09-AFC-6

RE: Scoping comments for the Chevron-Solar Millenium Palen and Blythe solar projects and the Nextera (FPL) Genesis solar project

These comments are being submitted on behalf of the California/Nevada Desert Energy Committee of Sierra Club. Most of the comments apply to all three projects; where noted, the comments are project-specific.

Figure 1. Dry Lake proposed alternative Solar Energy Study Area, Nevada. Cross-hatched area represents the NWP proposed SESA.

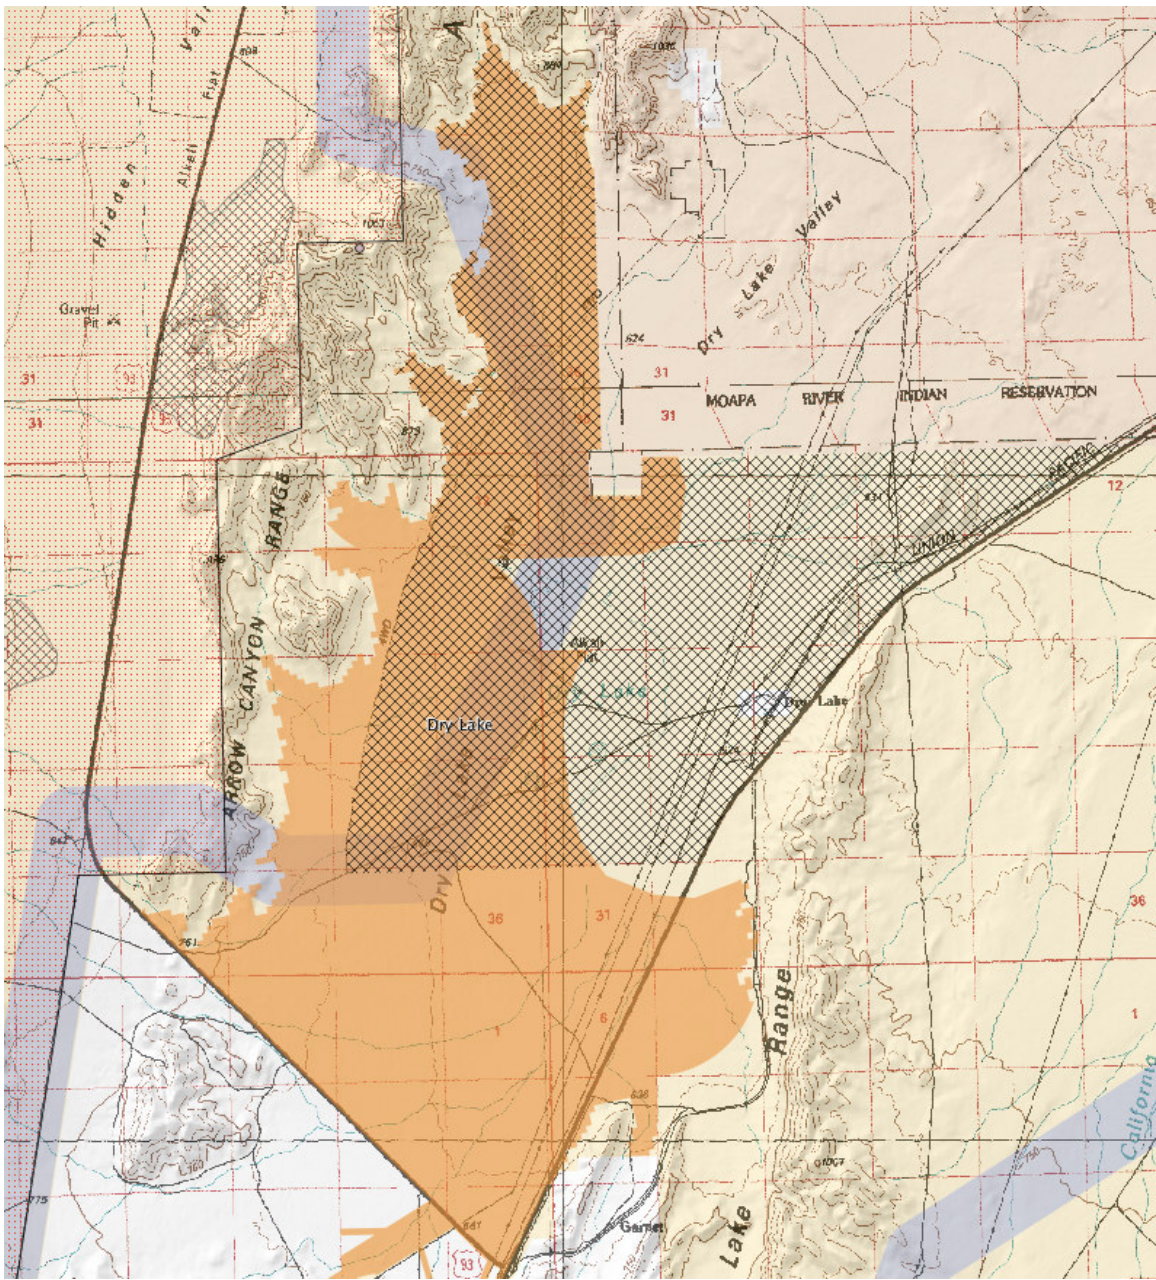
of the current SESA are excluded. The alternative SESA is approximately 13,500 acres (see Figure 1).

Figure 1. This map depicts overlap and conflict of the Mason Draw SESA with the New Mexico Wilderness Alliance’s BLM Citizen’s Wilderness Inventory Units.

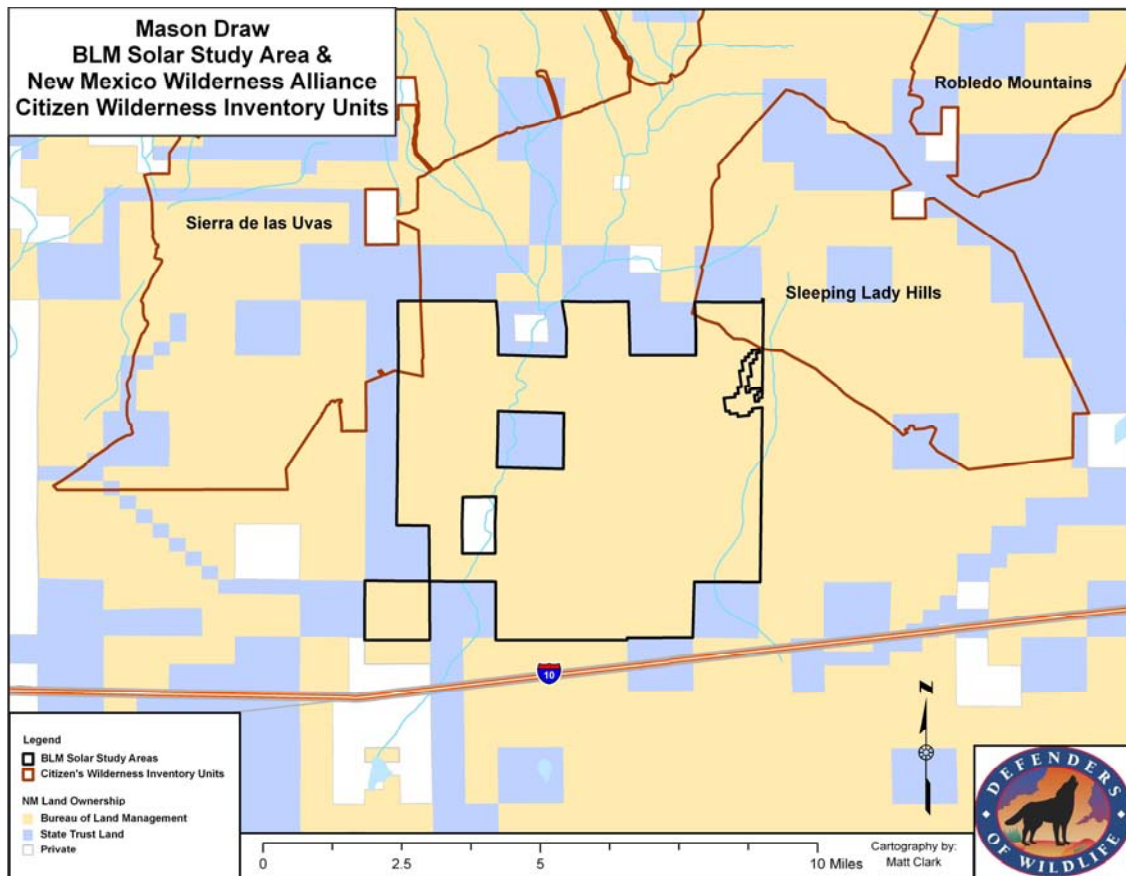
- This SESA intersects southwestern corner of New Mexico Wilderness Alliance (NMWA) BLM Citizens' Wilderness Inventory Unit "Sleeping Lady Hills" by approx. 350 acres and also clips the "Robledos-Las Uvas" unit by approx. 480 acres (see Figure 1; GIS data for the NMWA Citizens' Wilderness Inventory Units included in Exhibit 2 of broad comments submitted under the same cover as these New Mexico-specific comments). This overlap is unacceptable and unnecessary – the Mason Draw SESA should, at a minimum, be redrawn to exclude these inventory areas.

Figure 2. This map depicts overlap and conflict of the Mason Draw SESA with the BLM Habitat Management Planning Area for pronghorn and mule deer.

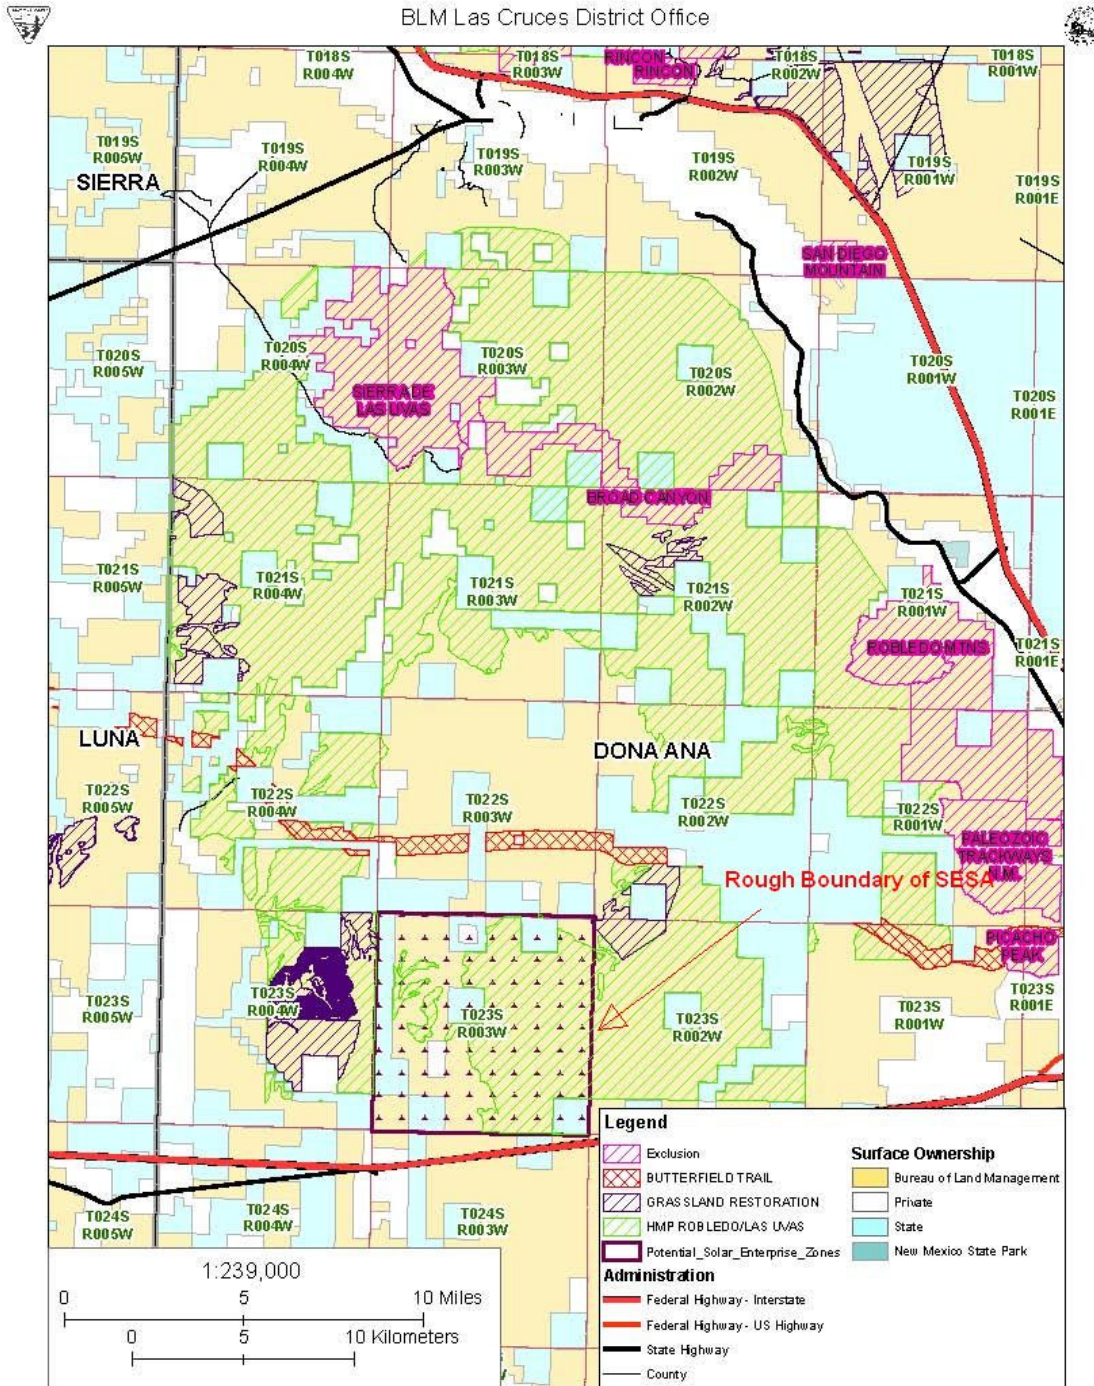
- This SESA is located within a BLM Habitat Management Planning area for pronghorn and mule deer (see Figure 2). Industrial solar development is not consistent with maintaining and/or improving habitat for these two species, both of which are very sensitive to roads, traffic, human development and disturbance.
- The Nature Conservancy (TNC), in cooperation with the BLM and other entities, conducted a Rangeland Ecological Assessment (REA) for the southern half of New Mexico. In this assessment, there are two areas totaling approximately 1,000 acres in the west and south of the Mason Draw SESA mapped as "unresolved", that may contain some grassland reference condition elements².

Figure 3. This map depicts the Red Sand Solar energy study area in relation to mapped units of TNC’s Rangeland Ecological Assessment reference conditions.

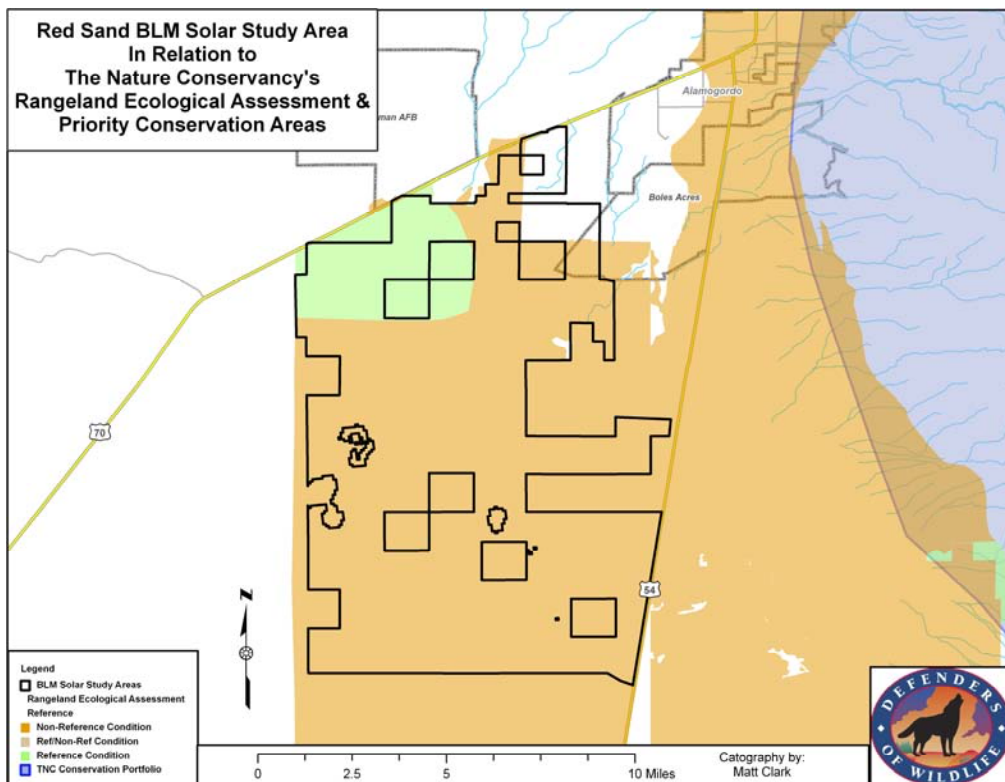
- TNC’s Rangeland Ecological Assessment identifies a grassland area in the northwestern portion of this SESA that contains approximately 6,400 acres of reference condition-quality grasslands (See Figure 3). Reference condition Chihuahuan desert grasslands are very rare, and BLM should carefully consider whether they are appropriate for inclusion in the SESA.

Recommendations: Based on conflicts identified by the BLM Las Cruces District Office and our own analysis, including the presence of playa lakes within the site, the extensive nature of the cultural resources, the development of habitat restoration projects underway in BLM's Renewable Resources division, and the presence of reference condition-quality grasslands as mapped by TNC, BLM should carefully consider whether or not to include all or some part of this area as a SESA. If the SESA is included, BLM should analyze the potential impacts of designating the SESA and the impacts of potential solar development in the SESA, identify opportunities to minimize and mitigate any potential impacts in the Draft PEIS, and require that impacts be minimized and mitigated.

Figure 5. This map depicts the Red Sand SESA in relation to NMWA Citizens' Wilderness Inventory Units and playa lakes.

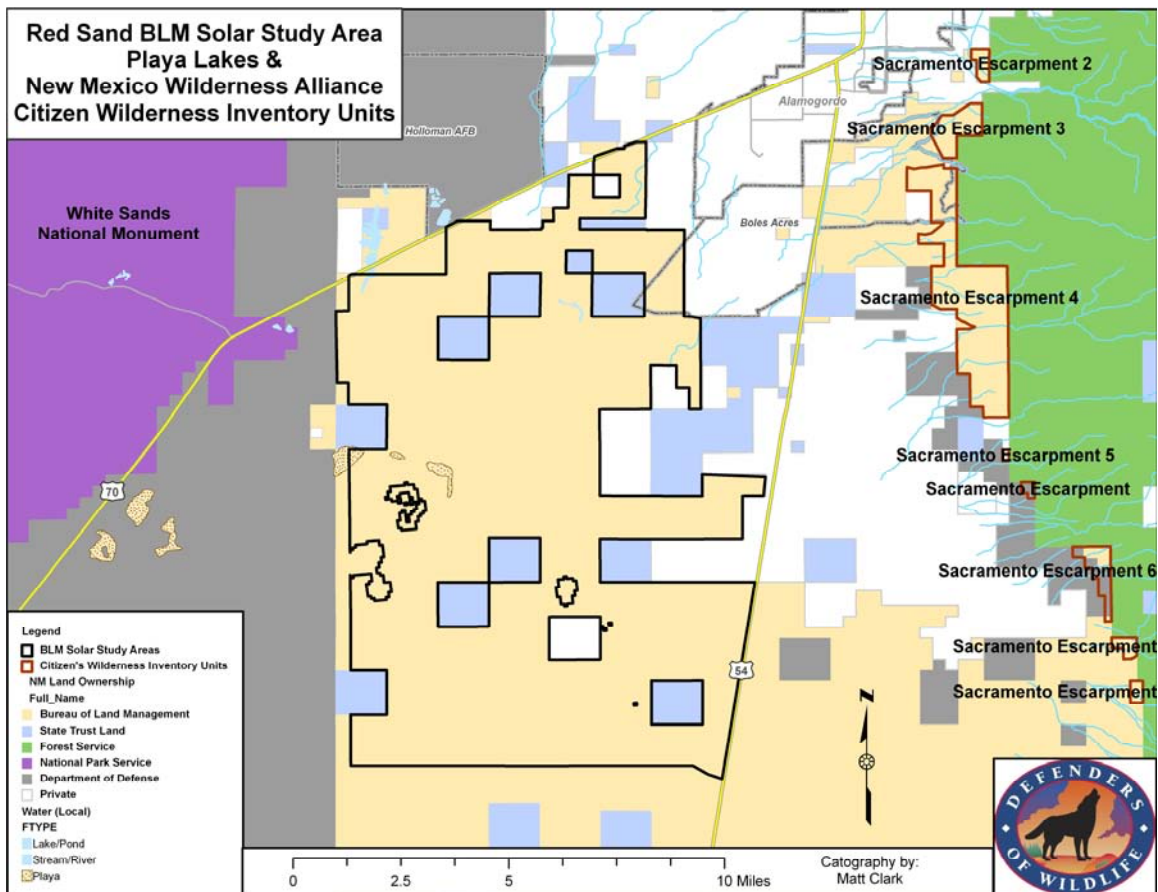
- The BLM Renewable Resources division is currently developing habitat restoration projects in this SESA. To the extent that lands within this SESA are targeted by BLM and conservation organizations for grassland restoration, BLM should carefully consider whether these areas should included in the SESA. Figure 4 shows TNC’s REA mapped restoration potential.
- This SESA contains several playa lakes, which provide seasonally important habitat and water sources for migrating birds and other wildlife species (See Figure 5).

Figure 6. This map depicts the Afton Solar Energy Study Area in relation to the USGS Southwest ReGAP wildlife habitat modeling reptile richness composite. Note the area in the eastern portion of the study area that contains relatively high reptilian richness.

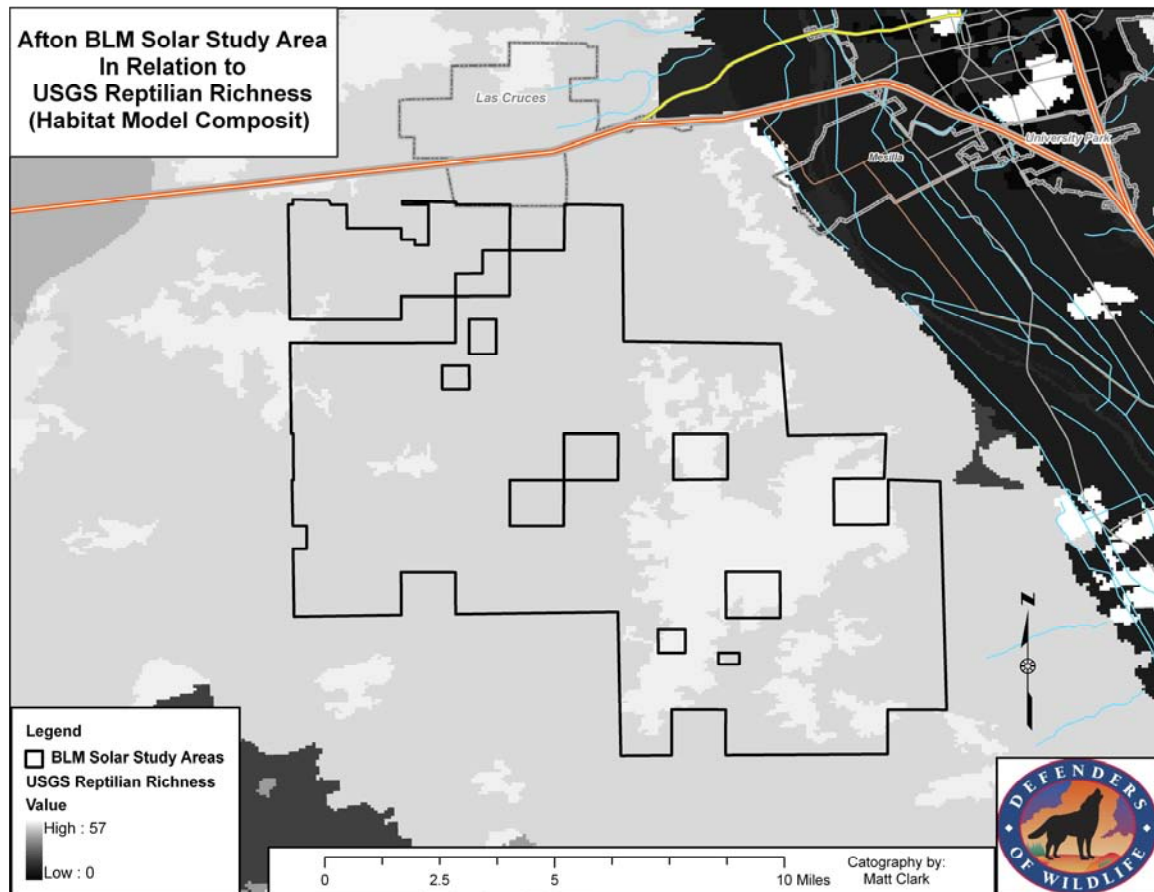
- Of the three SESAs in New Mexico, this unit appears to have the least conflict with sensitive natural resources. It is also close to existing infrastructure (Interstate 10 and an “existing designated corridor”) as well as a major metropolitan area (Las Cruces).
- According to USGS Southwest ReGAP terrestrial species predicted range modeling species richness composite, this SESA has high reptilian diversity in the eastern half (45 on a scale of 0-57) (See Figure 6).

Recommendations: Because it represents the SESA with the least amount of conflict in New Mexico, BLM should study the Afton SESA in detail in the Draft PEIS to determine whether the area is appropriate for solar development. BLM should also closely analyze areas with high reptilian diversity in the eastern portion of the SESA, and if serious conflicts are found the agency should consider avoiding them for solar development. BLM Las Cruces District Office has indicated that there may be areas adjacent to the Afton SESA which might be appropriate for inclusion in the SESA⁴ – BLM should evaluate those areas to determine if they are appropriate for inclusion. BLM should

Figure 7. This map shows the close proximity of the Afton SESA to the Aden Lava Flow Area of Critical Environmental Concern.

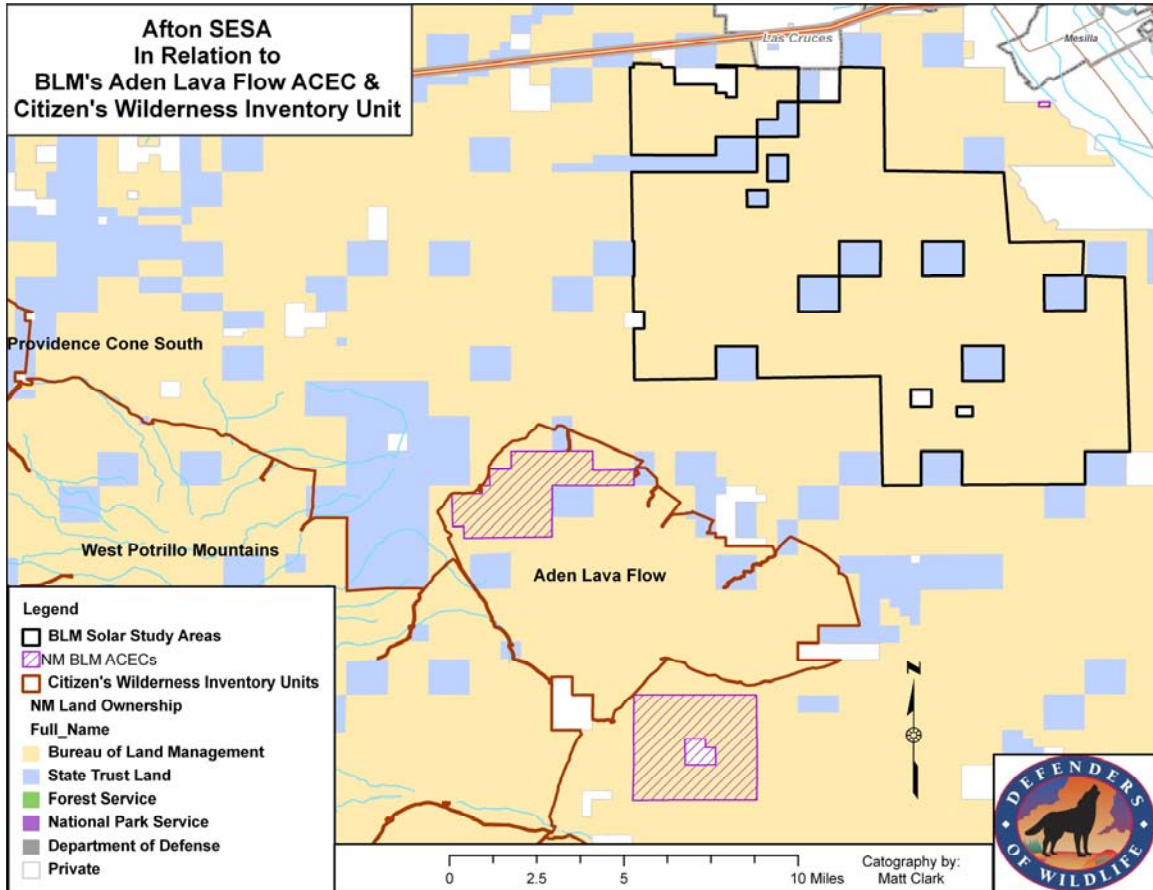
analyze the potential impacts of designating the SESA and the impacts of potential solar development in the SESA, identify opportunities to minimize and mitigate any potential impacts in the Draft PEIS, and require that impacts be minimized and mitigated. BLM should also analyze the potential impacts of nearby industrial-scale solar development on the scenic and habitat values of the Aden Lava Flow ACEC (see Figure 7 for proximity).
